Rotherhithe Cycleway consultation

Summary Report

November 2019

Section 15. Redriff Road (between Surrey Quays Road to Brunswick Quay)

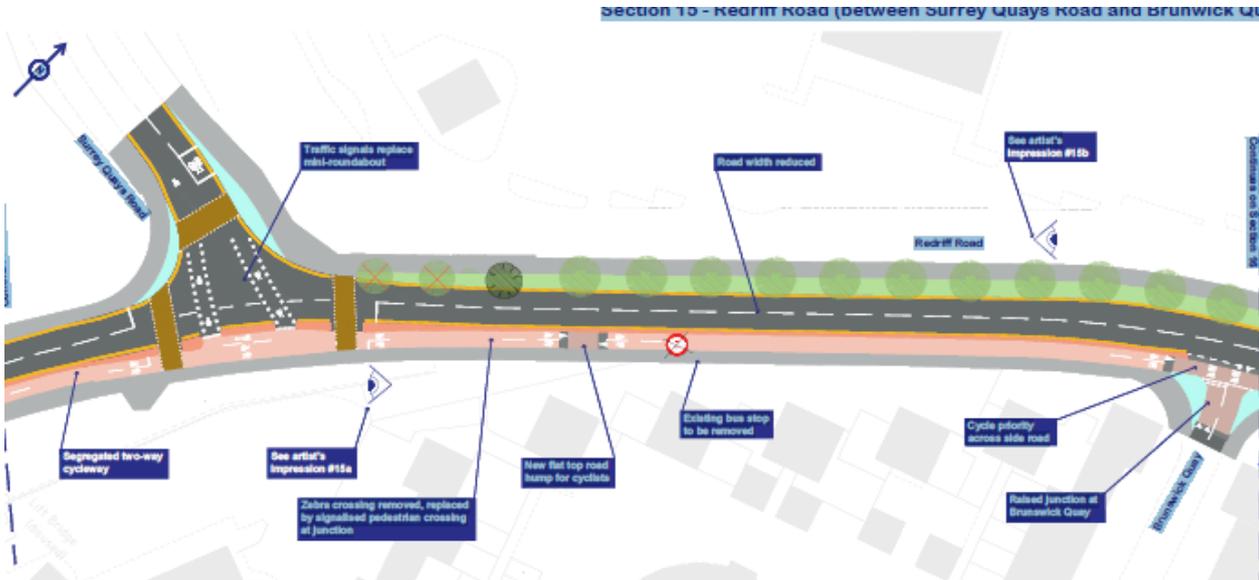
Comments and or suggestions	Response
<p>It will be good to remove the mini-roundabout as drivers mostly go straight over it anyway. It should reduce speeds. Good to remove the bus stop as it just causes delays for other traffic plus nuisance for residents with noise and rubbish thrown over fences by bus users.</p>	
<p>1. Traffic signals will significantly slow down local buses in the area, which are already very slow and it takes a long while to get to the nearest tube/overground stations. This adds a lot to overall commute time.</p> <p>2. Rotherhithe Street is very narrow and it's really struggling with 2 way traffic at peak times. A cycle track will only make the situation worse.</p> <p>3. The increased number of cyclists in the area will make it less safe for walking, especially for children and parents with a buggy, it will also increase the amount of garbage on the streets and will likely lead to the increased crime rate too.</p>	<p>It is not considered likely that the introduction of a cycle route will lead to a deterioration in the cleanliness or tidiness of the area</p>

Improve air quality	
Comments and or suggestions	Response
Cycle lane is meaningless in a street that is 1 lane each direction. Will increase traffic and queuing and increase pollution	The provision of safer cycle facilities will give people the opportunity to cycle rather than drive, which will assist in the improvement of air quality
it's not a very busy road so not sure a traffic signal is needed? Will only cause more traffic / cars standing still therefore more pollution	
I do not support any plan that seeks to encourage cyclists onto the roads carrying buses and lorries and major traffic flows . This is only encouraging them onto the roads with the traffic most likely to kill them. Better to create cycle routes by the river or through parks and nature reserve. Or failing that through side streets. Messing up Redriff road for traffic will create higher pollution .	
Ooops. No chance of ever moving along the road then. My God, my asthma problem is guaranteed to get far worse than it is already. Loss of ai-cleaning trees as well. UTTERLY GHASTLY.

Crossing roads is easy and safe	
Comments and or suggestions	Response
<p>Good to see better crossings for pedestrians</p> <p>Looks much safer for cyclists and pedestrians</p>	
<p>The placement of the Zebra crossing matches the path from Brunswick Quay and the pedestrian entrance to the cinema. It should be kept where it is. People will cross here anyway rather than needlessly walking to your proposed new crossing.</p> <p>There is also not enough traffic or footfall on this area to warrant a signalled pedestrian crossing here. The zebra crossing works just fine.</p> <p>I also strongly oppose the removal of the mini roundabout. This is not a busy junction and traffic signals will just cause delays. The roundabout works extremely well right now. You seem obsessed with signals throughout all the recent plans.</p> <p>I also strongly oppose the kerb on the segregated cycleway. This will make crossing the road with a pram very difficult.</p> <p>I personally do not use this bus stop, but why is it removed? Where do brunswick quay residents get their bus?</p> <p>I also strongly oppose the kerb on the segregated cycleway. This will make crossing the road with a pram very difficult.</p>	<p>The new crossing point is x metres from the existing crossing and will cater for those pedestrians heading towards Surrey Quays Road. The entrance into this site will no longer exist once this area is developed. So this design future proofs works when developments take place</p> <p>A zebra crossing so close to a signal junction would cause confusion and as a result would be unsafe</p> <p>New crossing are proposed along the route to allow pedestrians to cross Redriff Road and Salter Road</p>

Easy and safe to cycle	
Comments and or suggestions	Response
<p>Principle of promoting cycling is supported. Cycle lanes generally seem quite narrow, and would ideally be wider. Concerned by side roads pulling out into two way cycle traffic. These number of roads pulling out into cycle lanes should be limited to as few as possible to minimise the chance of collisions.</p>	<p>The width of the cycleway has been dictated by available space and the desire to minimise its effects particularly with regards to trees</p>
<p>Is it possible to also place a cycle lane along surrey quays road? even if its not segregated, a marking on the road would be beneficial.</p>	<p>This will be investigated</p>
<p>"New flat top road hump for cyclists": Why is this necessary?</p> <p>Why remove the "left"-most trees? These are mature trees.</p>	<p>The flat top hump is to avoid the expense of relocating a BT cover. This will be further explored during detailed design.</p>

There are a lot of daffodils planted under the grass verge on this section. I am not clear whether you plan to reduce the width of these verges or dig them up, but it would be a shame to lose the daffodils. If the contractors are due to dig up the verges or reduce their width can they be asked to put the daffodil bulbs to one side and then replace them when they put the earth back again?

<p>"New flat top road hump for cyclists": Why is this necessary?</p> <p>Why remove the "left"-most trees? These are mature trees.</p>		
<p>I oppose the removal of the trees.</p>		
<p>Oppose the removal of mature trees</p>		
<p>Loss of two trees is sad but segregated cycle path is most important</p>		
<p>Please plant an extra replacement tree as close as possible</p>		
<p>Please consider planting more trees</p>		
<p>Good to have separate cycle route and if you can't sort out a dedicated proper cycling route and put cyclist on road, good to have an advance light.</p> <p>But buffer zone, this needs planting, could be integrated suds system.</p>		<p>The buffer zone is only 0.5metres wide and is of sufficient width to accommodate planting</p>

I hope that the bus stop removal will be replaced with another bus stop close by and also that the cyclists will be policed - my experience is that they mount the pavement and are aggressive and will not stop at traffic lights

The verge is slightly narrowed at this point the daffodils look like they are close to the kerb. New daffodils will be replanted

At the next design stage we will continue this and investigate opportunities to plant additional trees

To provide a segregated cycle route, bus stops are designed to be on the main carriageway with the cycleway behind the bus stop. At this location this has not been possible, as we wanted to minimise the effect on the tress on the opposite side of the road.

Section 17. Redriff Road (between Omega Gate to Ropemaker Road)

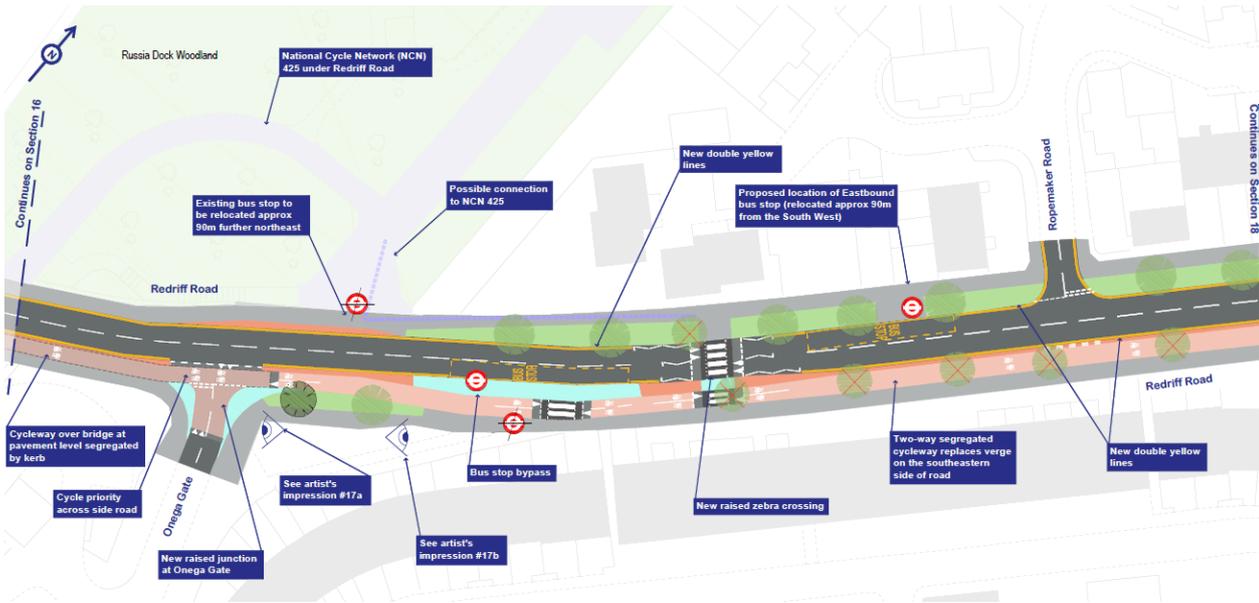
Segregated space for walking, cycling & driving	
Comments and or suggestions	Response
I think its extremely important to segregate cycle lanes from the rest of traffic. I have been commuting by bicycle on this road for nearly ten years and I have lost count of the number of reckless impatient drivers (cars, vans, buses and taxis) that have nearly or actually knocked me off of my bicycle.	
I think the camden kerb segregation over the bridge provides insufficient separation between cyclists and pedestrians. As the foot and cycle paths are at the same level, the design does not signal strongly enough to users of the paths that they are separated, not doing enough to discourage pedestrians from walking in the cycle path and, vice versa.	Improved footway will reinforce the difference between the footway and the cycleway and encourage both pedestrians and cyclist to use there area. There will be a change in footway material will provide clear visual distinction from cycleway.

Accessible for all	
Comments and or suggestions	Response
Removal of bus lanes will cause congestion on a road that is currently not congested creating pollution. Narrower pavement is not desirable for pedestrians especially those with buggies.	To provide facilities for all we propose reduced width for all road users, motorist, cyclists and pedestrians. The narrowest widths are still within acceptable standards and have been kept to a minimum.

Section 18. Redriff Road (between Norway Gate and Quietway 14 connection)

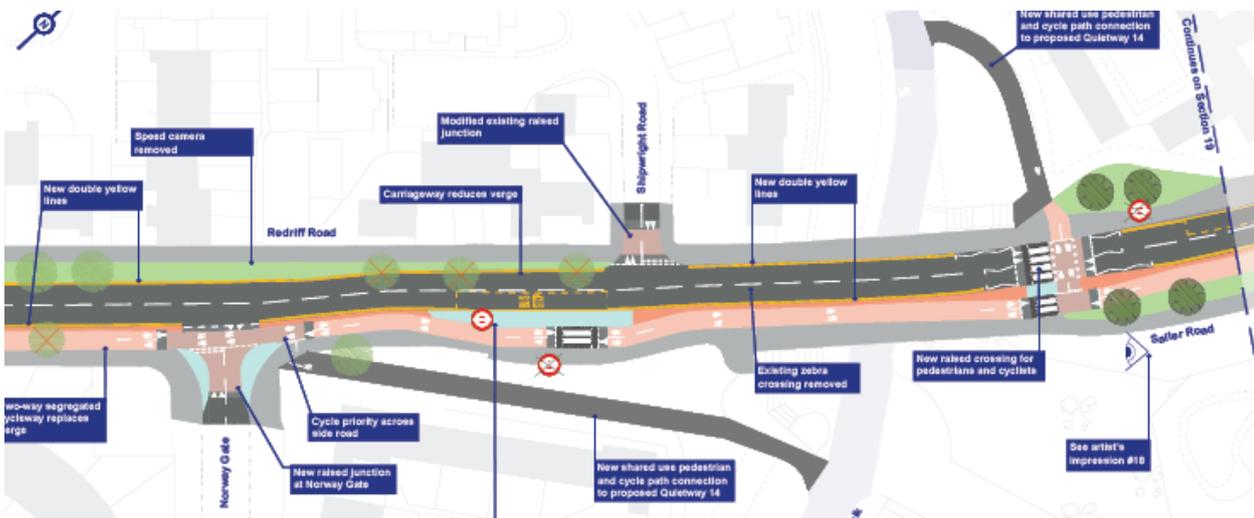
Strongly oppose the removal of mature trees.	
Please refer to previous comments which equally apply. (Removal of bus lay bys will mean that traffic will be stopped as there will be inadequate room for

<p>passing. This will cause traffic delays.</p> <p>Cycle lane and width restrictions not required as no one will use it - there will not be a Rotherhithe Bridge.</p> <p>Don't forget that the road speed in this area is already restricted to 20 mph.)</p>	
<p>I am concerned at the removal of the bus lay bus and the effect this will have on the movement of traffic in this and the proposal generally. In an ideal world i would have no issue but as a cyclist I recognise that frustrated drivers can be dangerous drivers.</p>	
<p>Taking away bus lay bys and loss of grass verges is madness , the grass verges help to give the area character</p>	
<p>There should be no reduction in motor vehicle carriageway width as a result of introducing a cycle track.</p> <p>There should be no loss of grass verges.</p> <p>There should be no loss of bus lay-bys</p>

Moving bus stops...transport for locals to enable cyclists to get to & from work work?

Support, although i'm concerned about the removal of the bus stop to the north of the road as it is one myself and friends use regularly

Pedestrian crossings are not close enough to the bus stop - people will still run across the road and will have issues with both the normal road and the bike lanes now.

Where is the bus stop in the direction of Rotherhithe station going to be? Now seem very far apart

would require loss of planting, which we have tried to minimise.

Section 20. Rotherhithe Street (Bryan Road to Durand's Wharf)

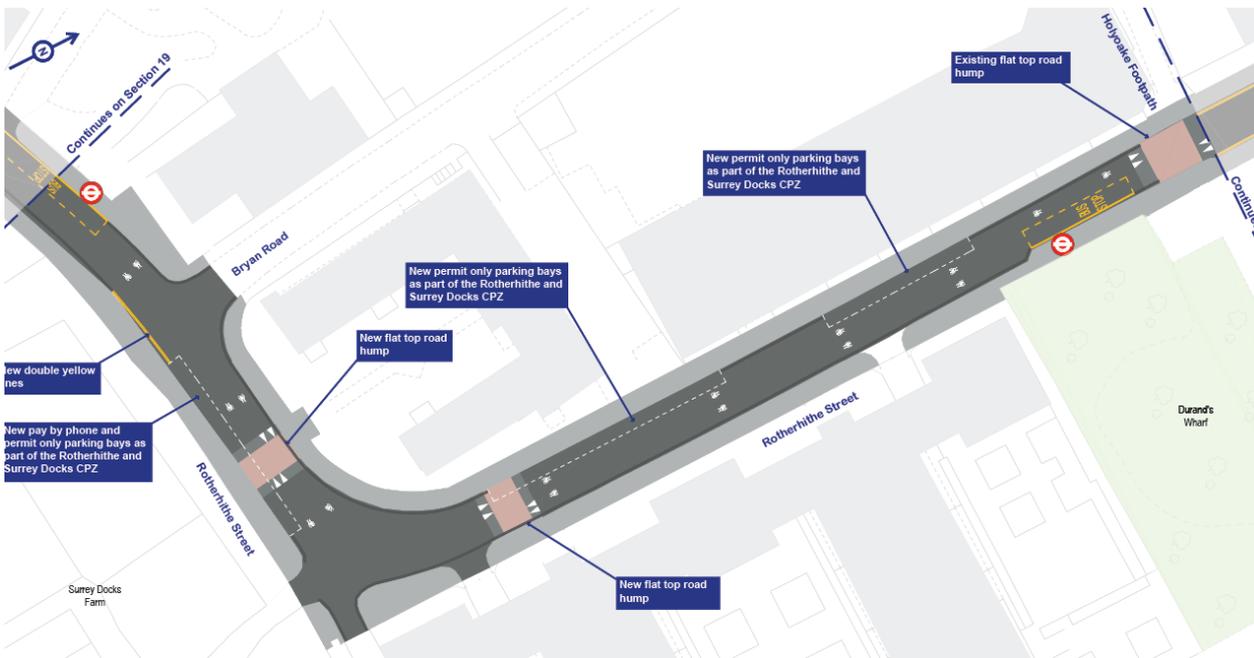
Improve air quality	
Comments and or suggestions	Response
<p>Oh dear. More speed bumps!! Don't know why you need them, as the traffic by now will be completely gridlocked for days on end.</p> <p>My heart goes out to the poor animals inside Surrey Docks Farm who will almost certainly die from the increased air pollution, but are not even able to complain about the madness of all this. UTTERLY BONKERS!!!</p>	<p>The provision of safer cycle facilities will give people the opportunity to cycle rather than drive, which will assist in the improvement of air quality</p>

Safer speeds	
Comments and or suggestions	Response
Painting bikes on the road does not make a safe cycle route. If people on bikes are to share the highway with other vehicles there needs to be a significant amount of filtered permeability. Traffic at low speed and low volume only. This scheme does not provide that.	Rotherhithe Street is used predominately by local traffic and is not considered to be taking rat-running traffic. As Salter Road is the only road alternative and is considered most likely to be a route traffic would choice to use, which will help to keep traffic volumes low. The position of traffic calming features should ensure reduced speeds

Safety	
Comments and or suggestions	Response
Double yellow lines needed, with a small area near the farm for parking. Leading up to this area is a pinch point with C10 buses having trouble, passing. Add one lane open, because of buses stopped, cyclists and cars on the blind bend and there will be (are) accidents.	The kerb is being realigned at this point together with new road humps which will help reduced the speed of vehicles
I find parking by the side of the road a danger to cyclists. Eg car doors opening cyclist swerving into line of traffic and injured as a result.	To mitigate against this we have only provided parking bays on one side of the road, which on this section provide between 5.3 and 7.4 metres

Section 21. Rotherhithe Street (Durand's Wharf to Silver Walk)

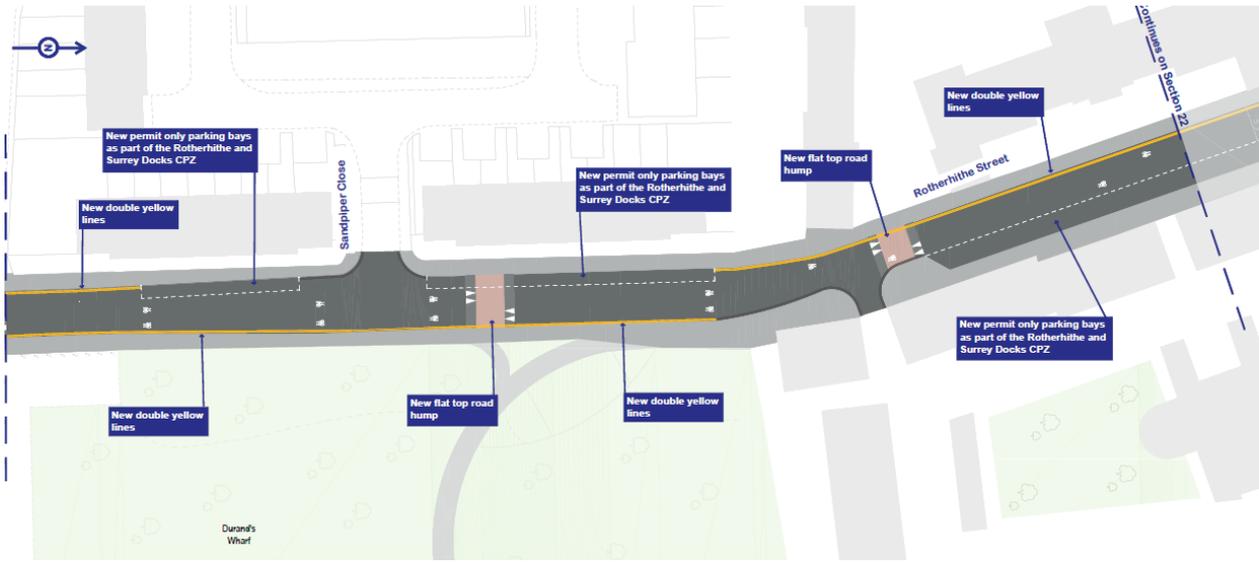
Improve air quality	
Comments and or suggestions	Response
<p>I OPPOSE HAVING ANY HUMPS OUTSIDE OF MY HOUSE!! ABSOLUTELY NOT!!</p> <p>PARKING IS ALREADY RIDICULOUS ON THE WEEKEND, THERE IS NO NEED FOR SPEED BUMPS, THEY INCREASE TRAFFIC POLLUTION BY DRIVERS EXELLERATING AND BRAKING!</p> <p>The buses already shake out houses let alone any further plans to shake the whole street.</p> <p>USE SALTER ROAD!!!</p>	<p>The provision of safer cycle facilities will give people the opportunity to cycle rather than drive, which will assist in the improvement of air quality</p>
